TRANS/WP.29/GRPE/2003/16
10 March 2003

PROPOSAL FOR DRAFT AMENDMENTS TO DRAFT SUPPLEMENT 2
TO THE 01 SERIES OF AMENDMENTS TO REGULATION No. 67
(Equipment for liquefied petroleum gas)

Transmitted by the expert from Italy

Figure 3: Connecting area of the light vehicle Euro filling unit"

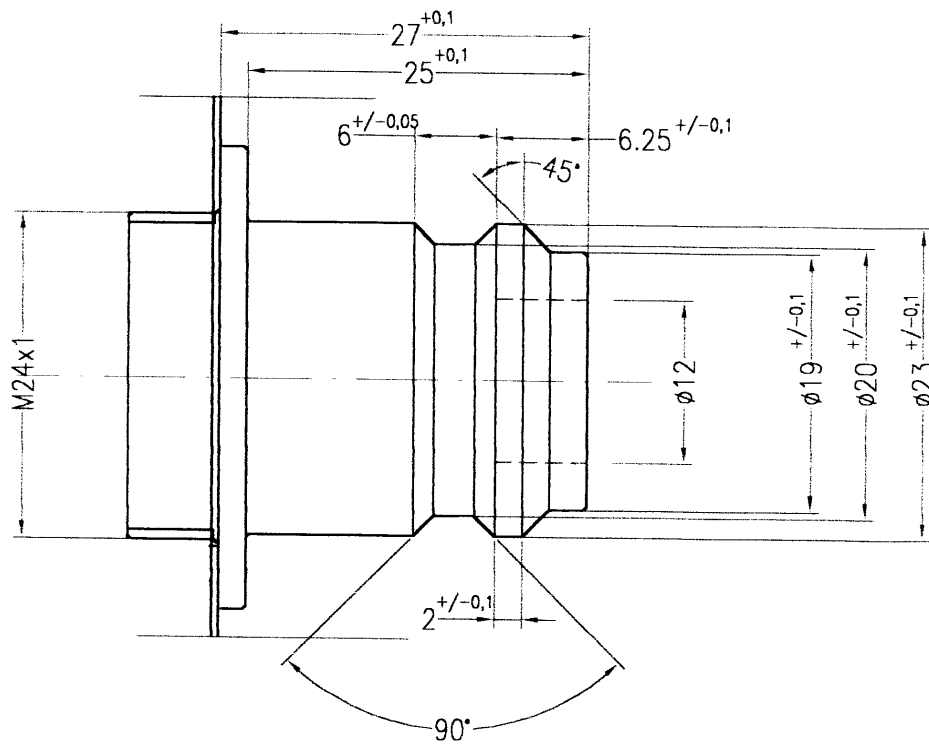
Figure 3. amend to read:

Italy supports the proposal for an Euro filling unit. However the technical solution should also take into account the LPG vehicle fleet which is mainly made by retrofitted vehicles. For this reason a connector with a reduced size would be suitable. Further justification may be found in informal document No. 5 distributed during the forty-third session of GRPE.
